**ANN ARBOR PLANNING DEPARTMENT STAFF REPORT SUPPLEMENT**

**SUBJECT: 841 Broadway Zoning and Area Plan (841 Broadway Street)  
File Nos. Z18-018 and AP18-003**

## ANN ARBOR PLANNING DEPARTMENT STAFF REPORT

Re Response to March 5 City Planning Commission Comments  
PUD Zoning District Review  
Broadway park, Ann Arbor, MI

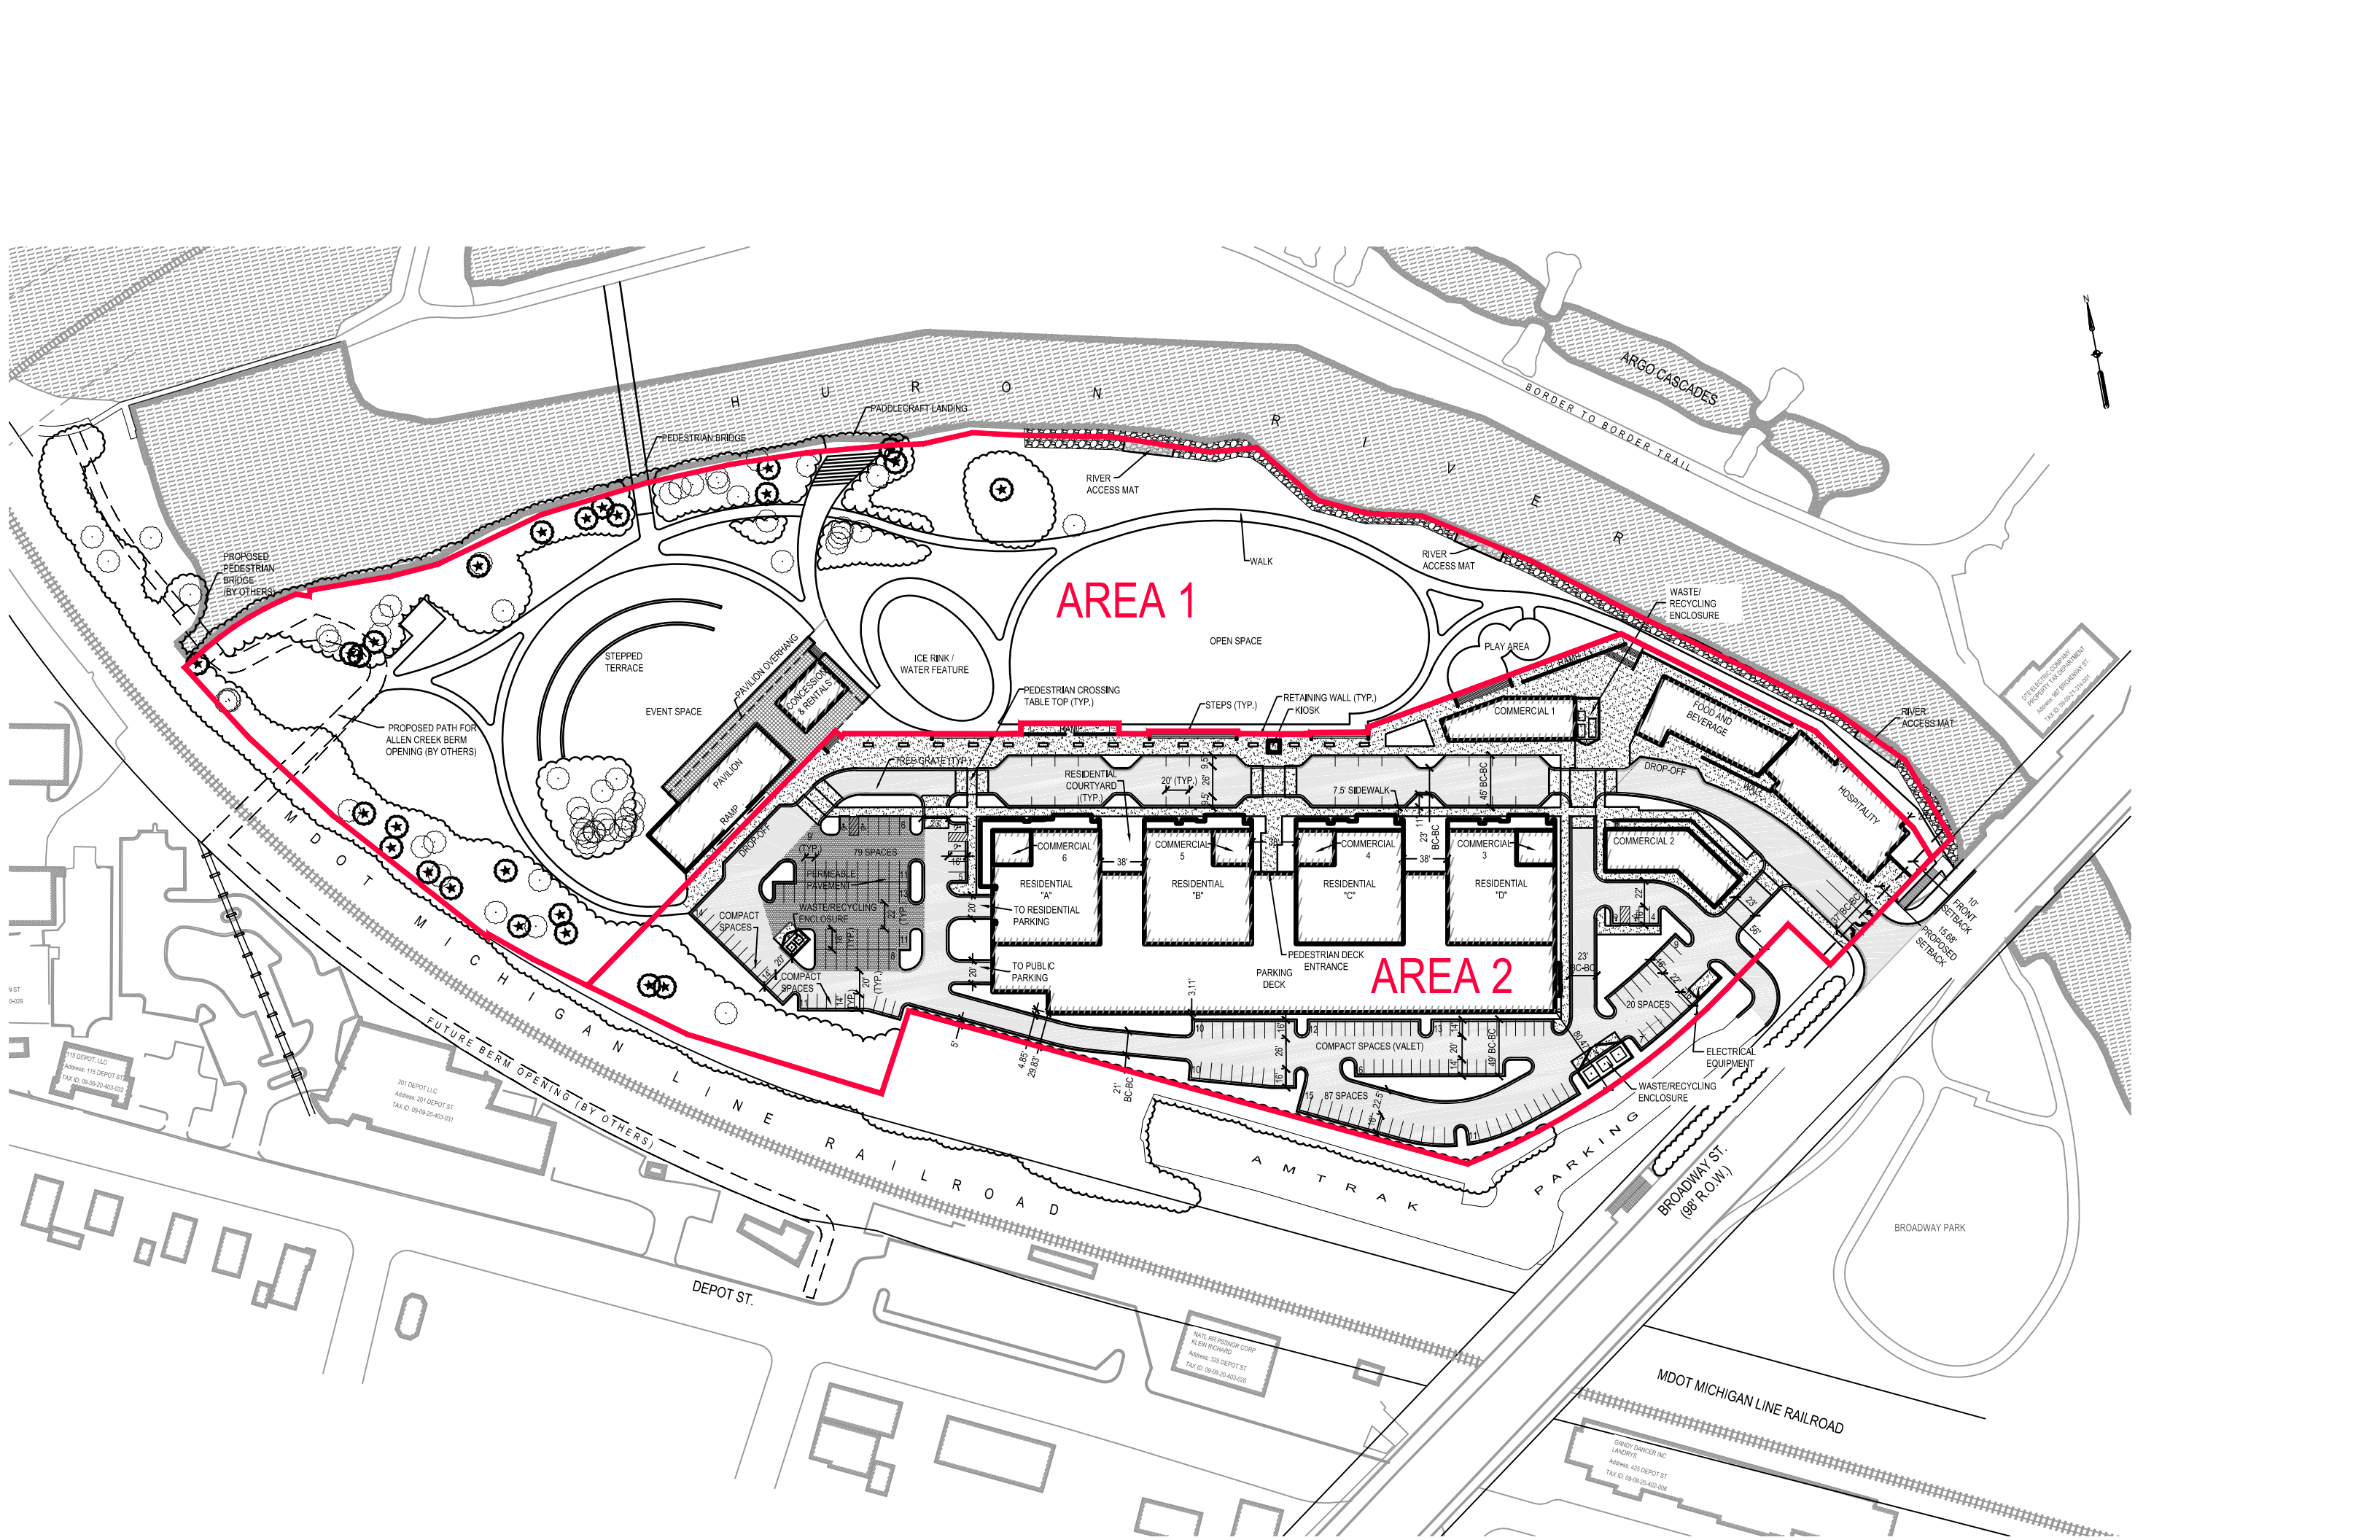
In order to help delineate designated use areas, the attached map indicates areas where proposed uses are permitted depending on access provided to the site. These area designations correspond directly to the supplemental regulations where permitted/required uses are described in detail.

a. Area 1 (Attachment A):

Required Principal Uses: Open space - The approximate area of Area 1 as designated in Attachment A shall be designated as permanent open space with limited recreational and associated uses permitted. In no case shall such area be less than six contiguous acres.

~~a.b.~~ Area 2 (Attachment A):

Required Principal Uses: Multiple-Family Residential: Minimum 90 units. These units will have a maximum of 3 bedrooms per unit, with the exception of not more than eight (8) units which may have up to five (5) bedrooms.
